TOLEDO CITY
PLAN COMMISSION
REPORT

July 9, 2015

| 4. SPR-1-15: | Major Site Plan review for multiple buildings on a lot at 3905 Stang Road (gp) |

SITE PLAN

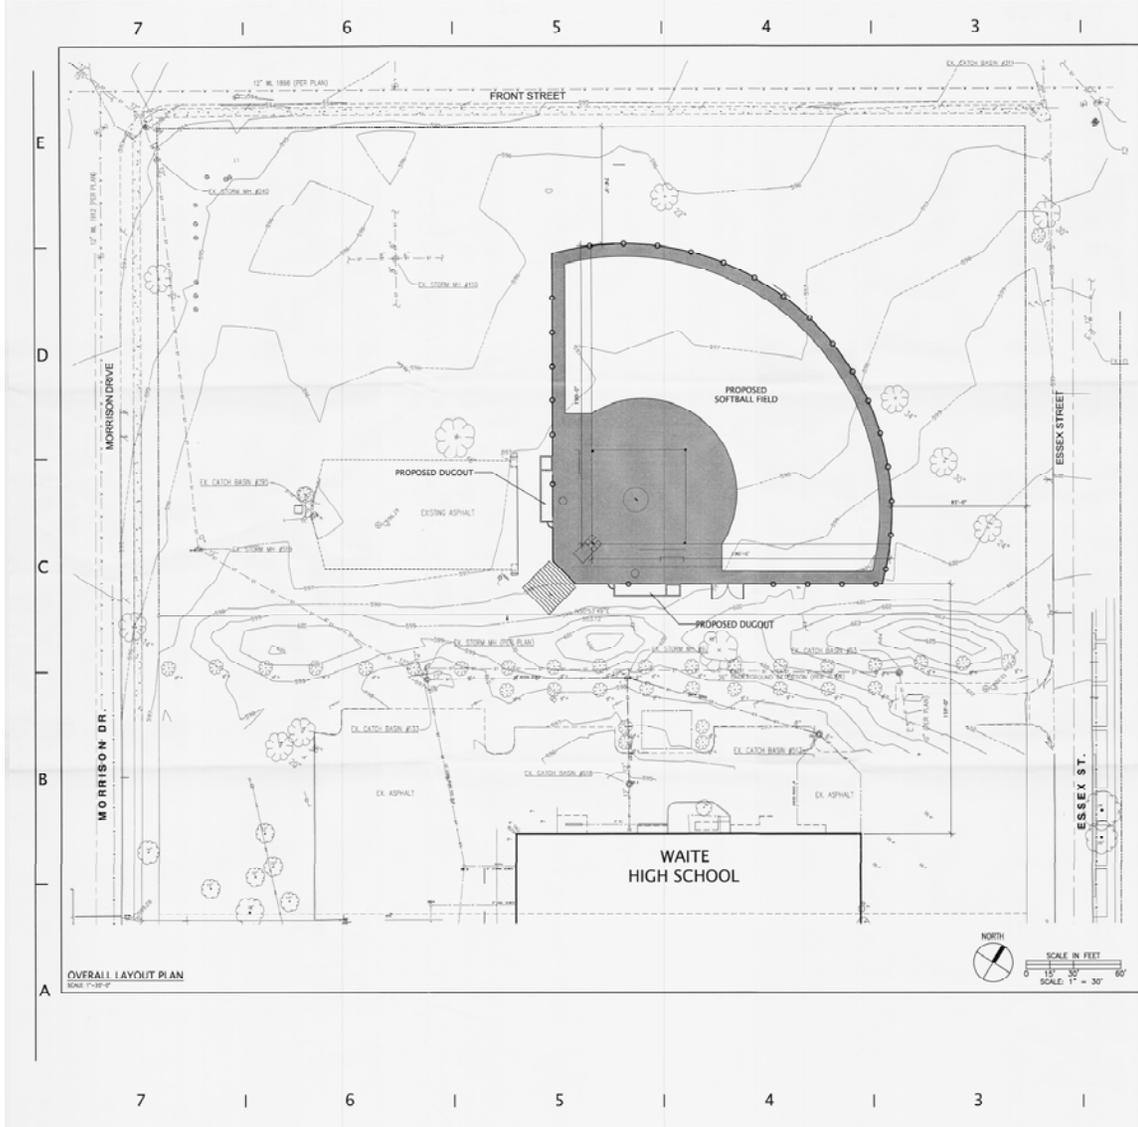
- a. A frontage greenbelt shall be provided along the street or place right-of-way and shall be a minimum fifteen (15') foot wide (**acceptable as depicted on the site plan**);

- b. At least one tree must be provided in the frontage greenbelt for every 30 feet of lot frontage or fraction thereof;
 - c. The location, number, height, diameter and species of any materials to be planted and maintained, as well as the location and number of any existing trees to be retained, trees, shrubs, and landscape materials shall meet the standards included in TMC 1108.0400 Landscape Materials Standards; **acceptable as depicted on plan.**

- d. Landscaped areas may not contain bare soil, aggregated stone or decorative rock. Any ground area must be covered with hardwood mulch, grass or other vegetative ground coverage; **shall be noted on landscape plan.**

- e. The location, height and materials for any fencing to be installed and maintained; **shall be noted on landscape plan.**
 - f. The location and direction of any proposed lighting (lights are to be directed away from adjacent residential properties); **shall be noted on revised landscape plan.**

ELEVATION

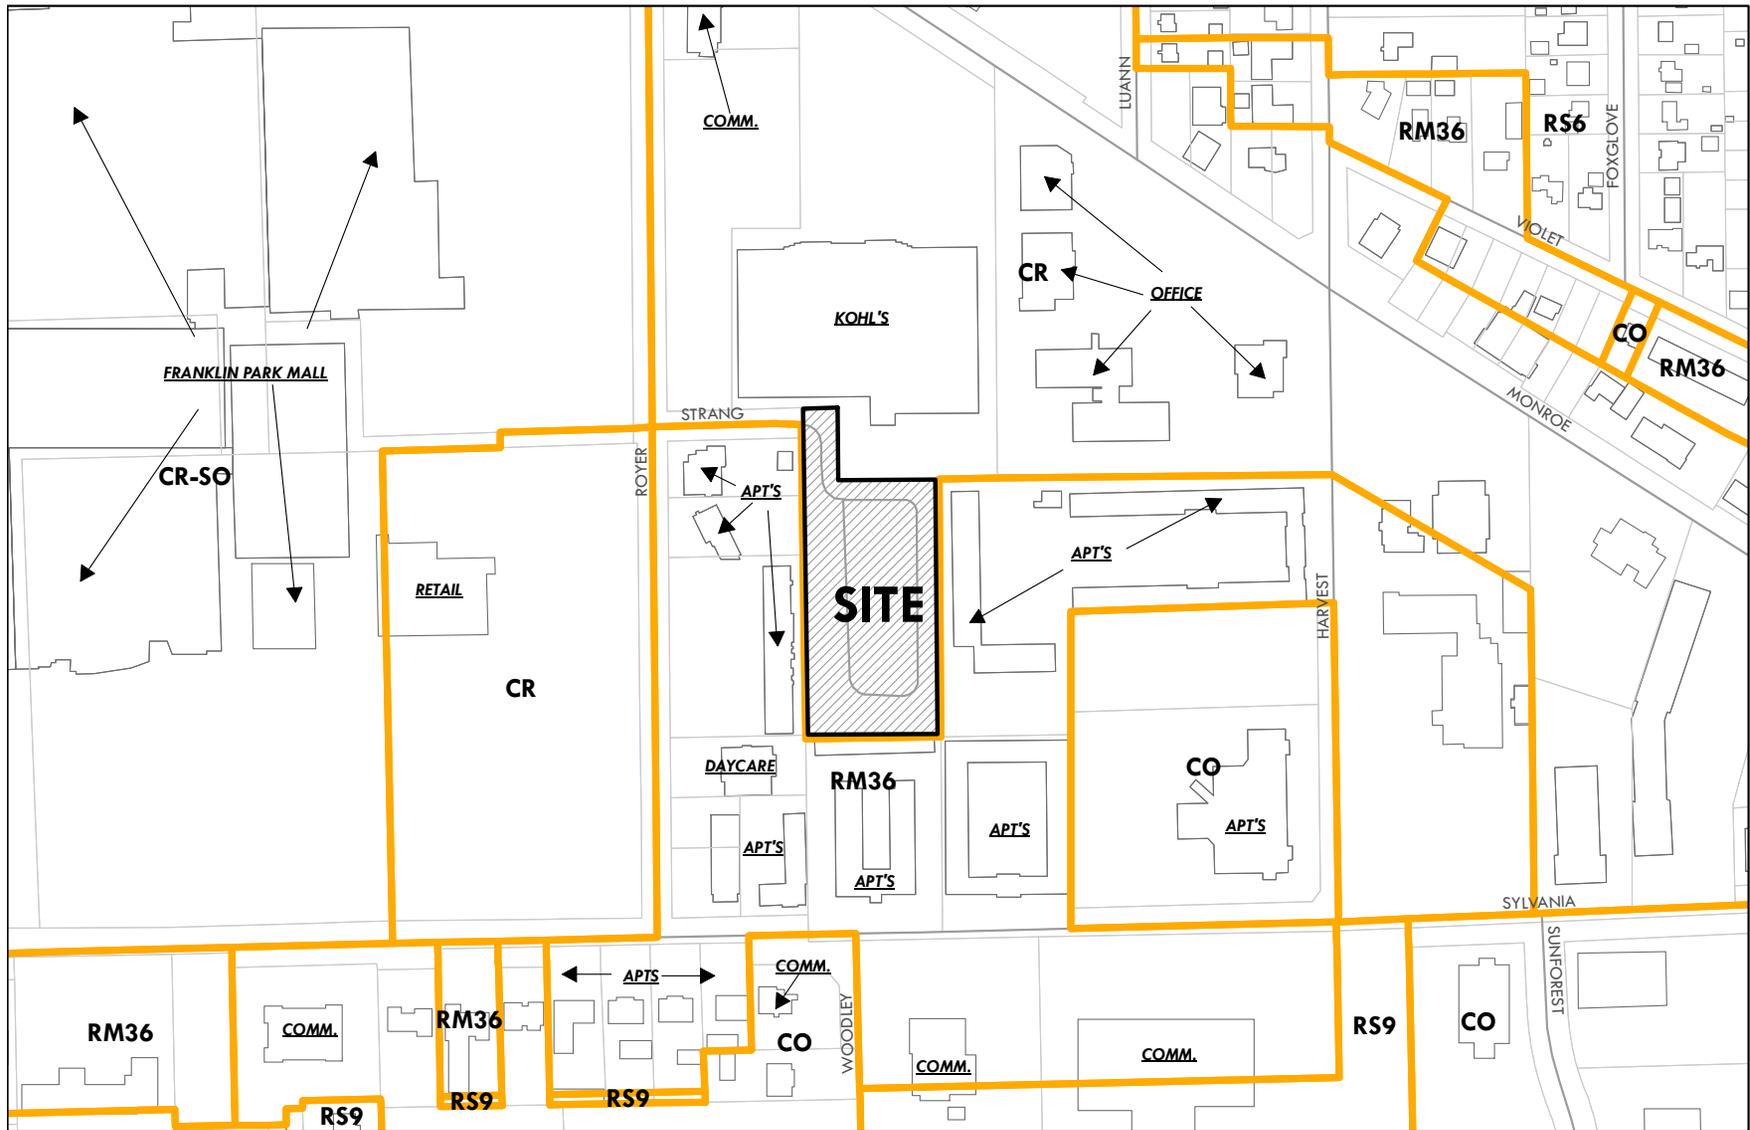
42. The building materials shall meet the requirements of TMC§1109.0500 *Building Façade Materials and Color*. Elevations shall be submitted to meet the approval of the Plan Director. **The submitted elevations shall be revised to include additional detail on the type and color of material. Exterior façade materials shall meet the criteria of TMC§1109.0500.**
